**ADDENDUM NO. 2**

**For: Elementary School # 38  
522 Brookewater Boulevard  
Rosenberg, TX 77471  
for  
LAMAR CISD  
3911 Avenue I  
Rosenberg, TX 77471**

**ADDENDUM DATE: January 10, 2025**

**PROJECT NO: 24-028**

100% CONSTRUCTION DOCUMENTS  
**A6.03**  
 EXTERIOR ELEVATIONS

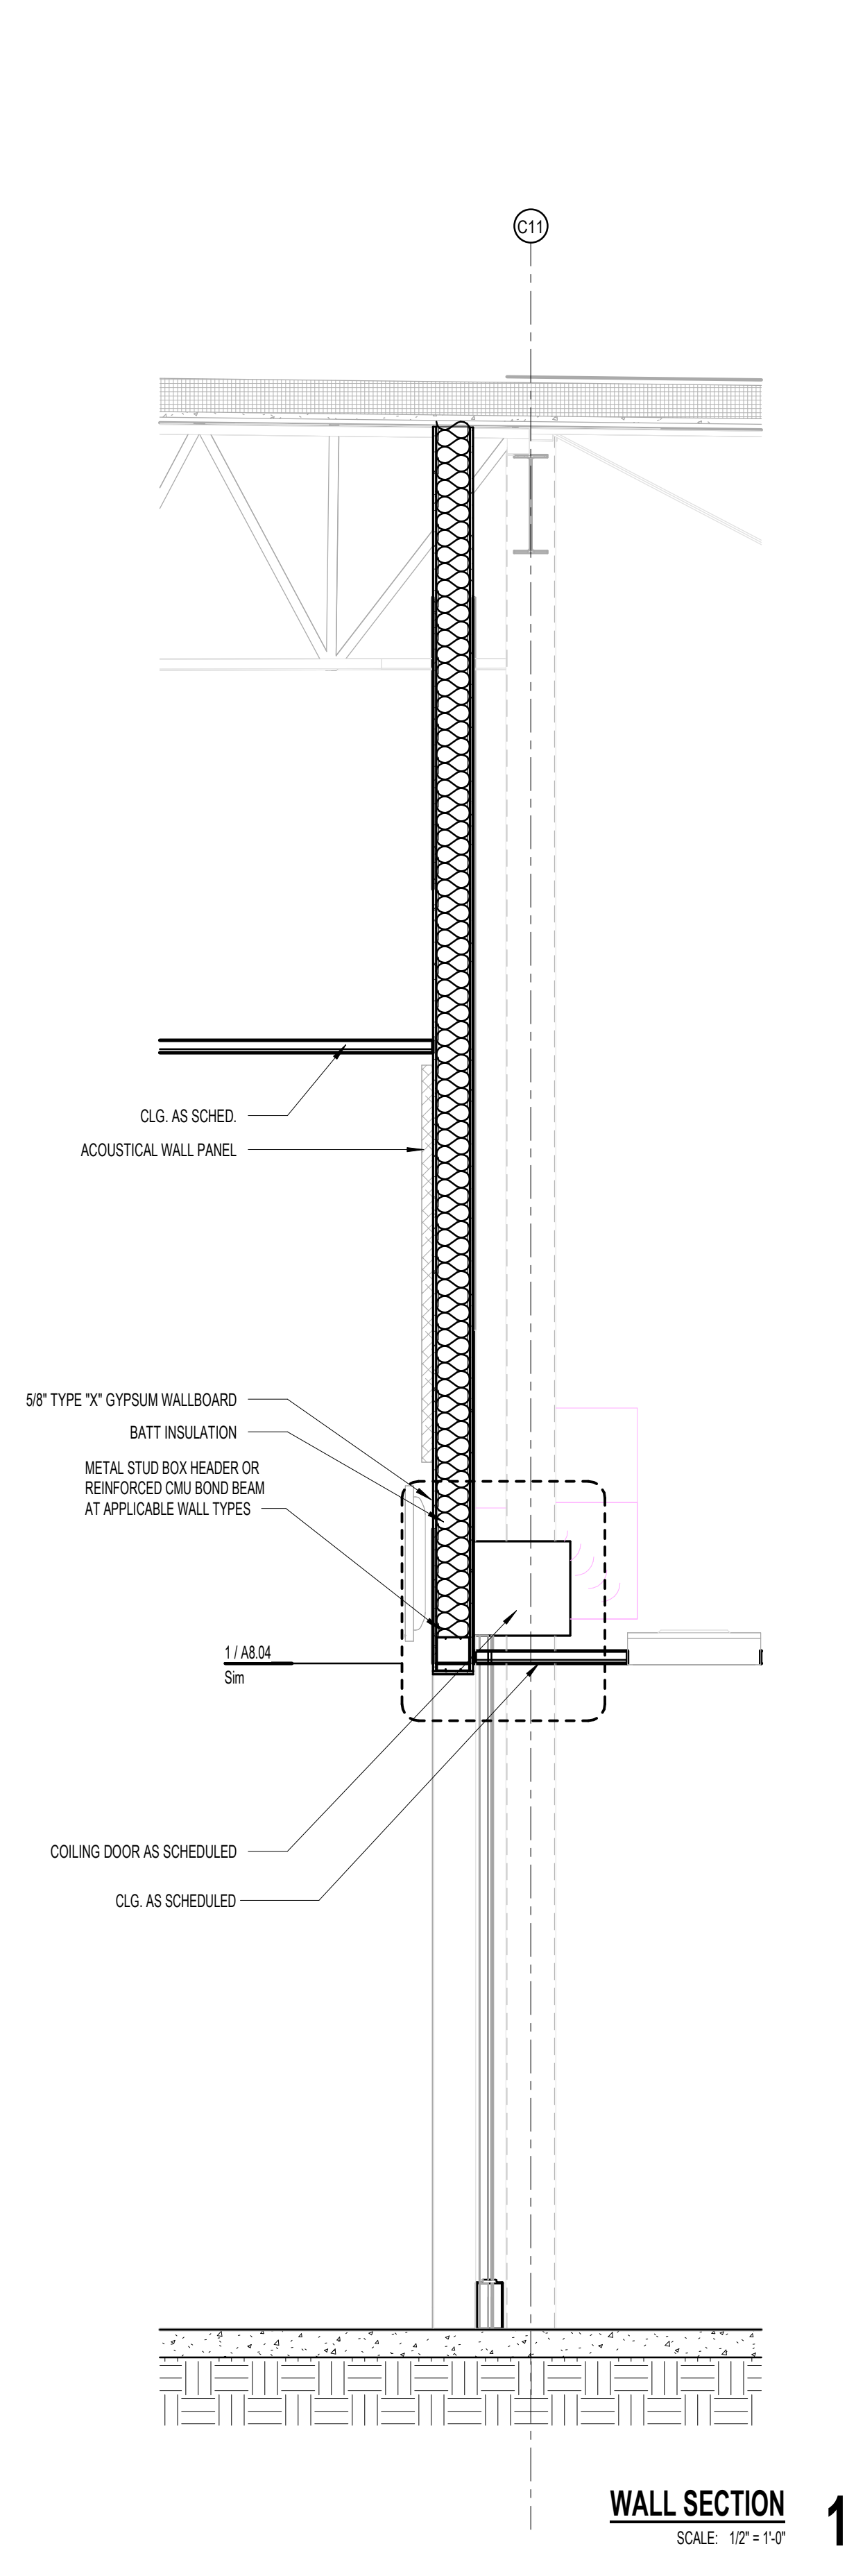
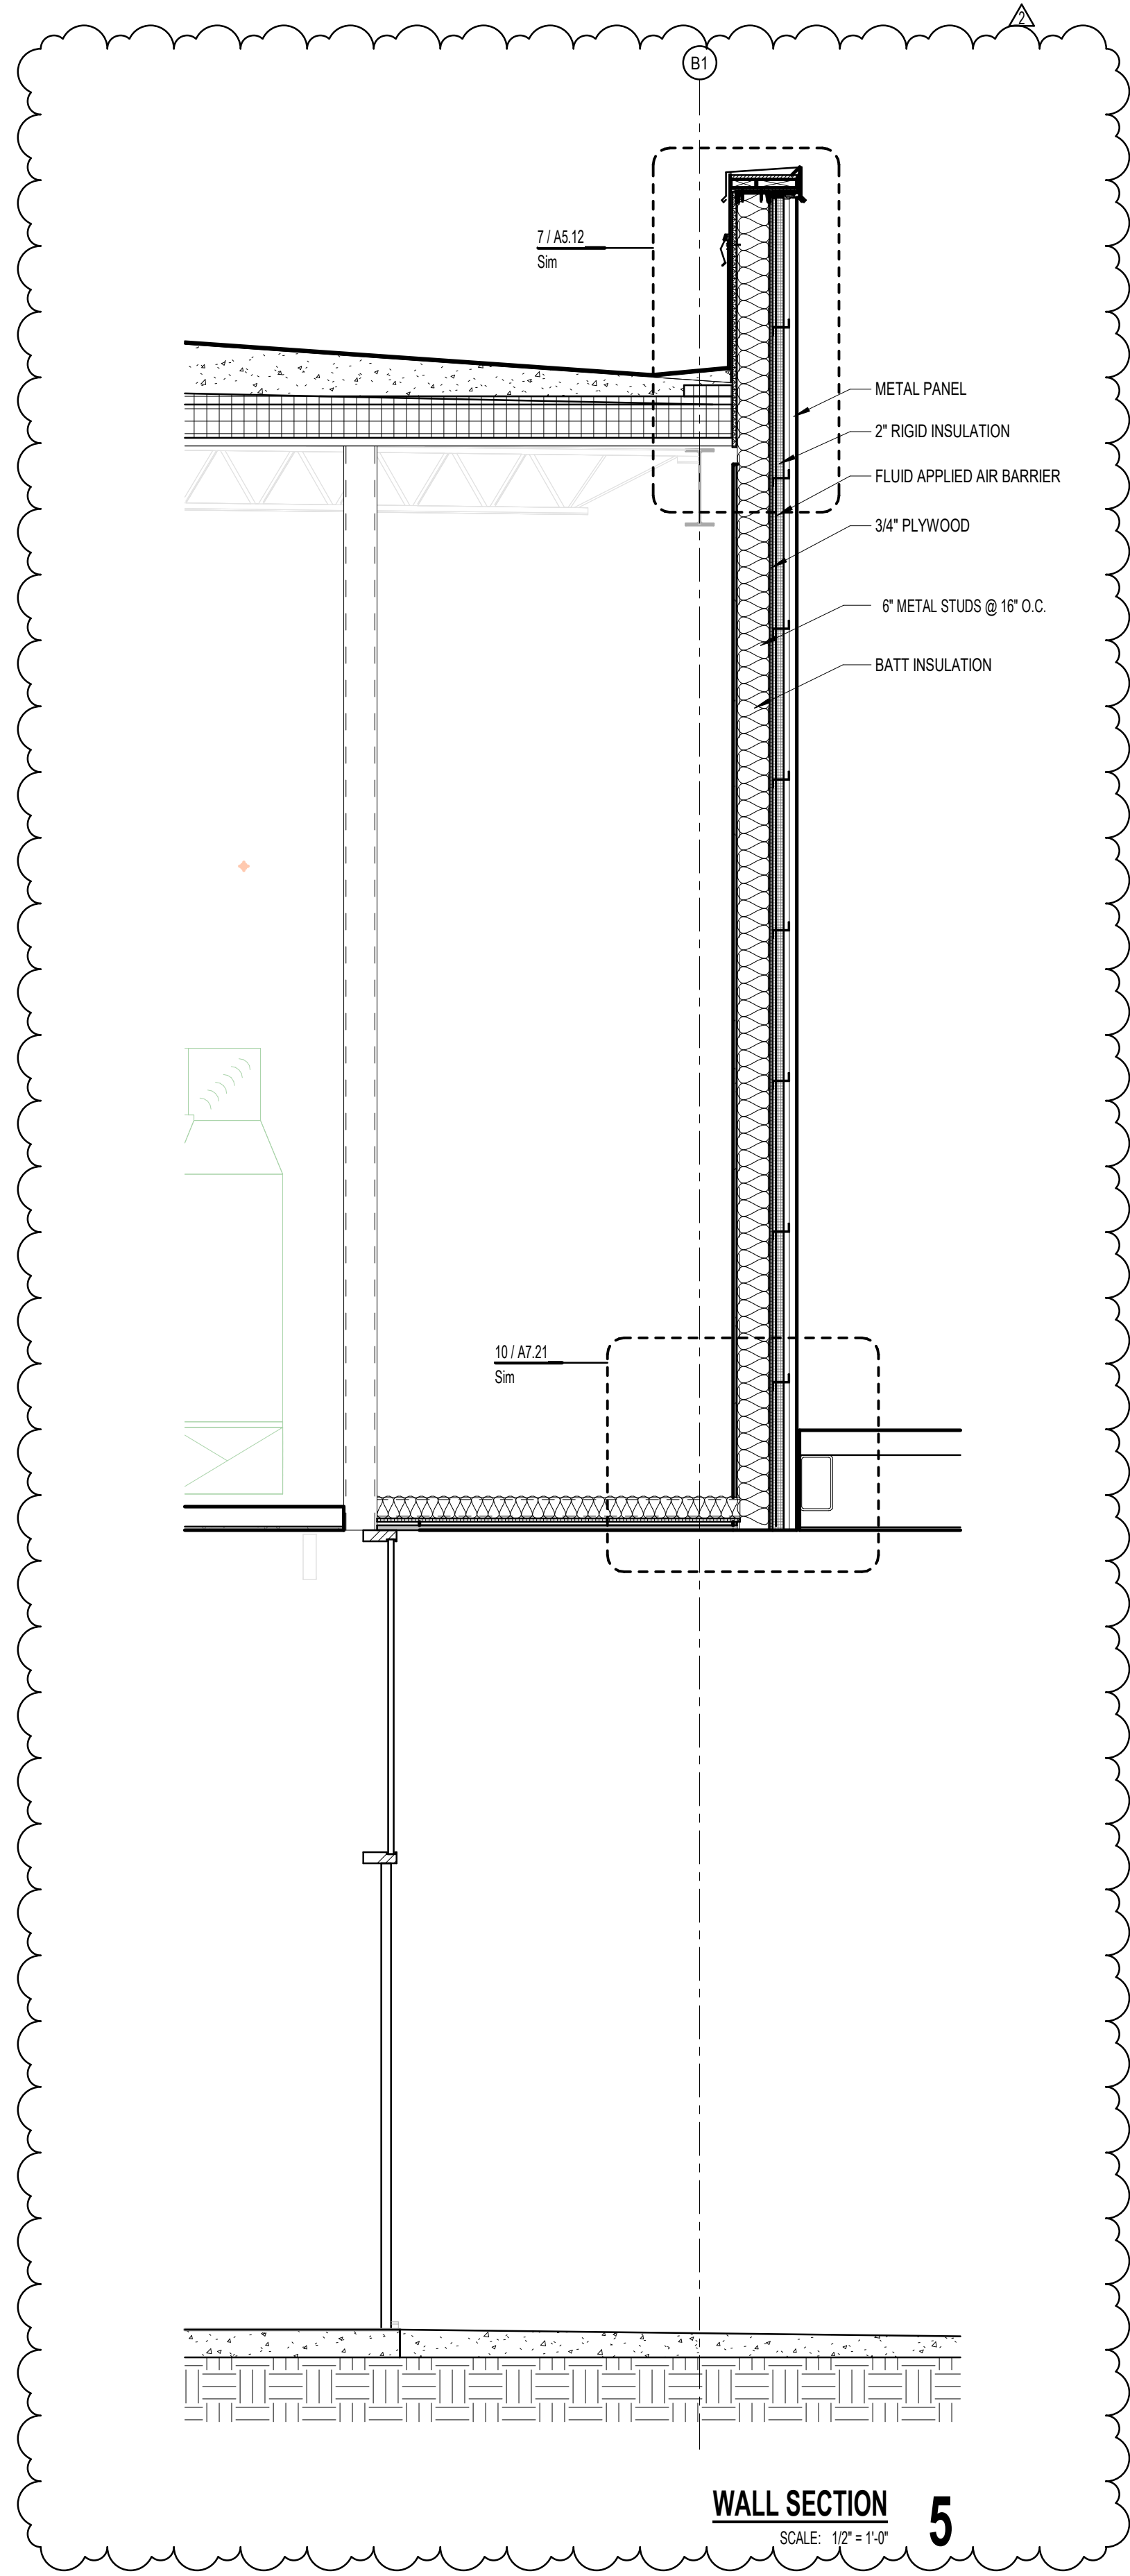
D2-46	A5.01F	Called out downspouts on multiple canopies
D2-47	A6.01	Changed detail callouts on elevation 2 and 9.
D2-48	A6.03	Added louvers to mechanical yard
D2-49	A6.03	Modified Gate S010 to be double swing gate
D2-50	A7.08	Added Section 5
D2-51	A7.20	Revised detail 9
D2-52	A7.21	Revised notes for fire treated wood on detail 5
D2-53	A8.00	Door C108E Added.
D2-54	A8.00	Type K Doors note modified to be "Open Grille Coiling Overhead Door".
D2-55	A8.00	Updated door B101C to hardware set 2
D2-56	A8.03	Added frame type 29
D2-57	A8.03	Added detail references for frame type H1
D2-58	A9.00B	Added room C108E
D2-59	A9.00B	Updated Ceiling types for B105, B128, E115, E127, F127, C113
D2-60	A9.00A	Added general note regarding Fine-Fissured Ceilings
D2-61	A9.10	Elevation 28 modified, cubbies are NIC and part of FF&E
D2-62	A9.10	Elevation 17 at Lounge, note modified to say "VENDING IN CONTRACT"
D2-63	A9.13	Adjusted display cases on elevation 1
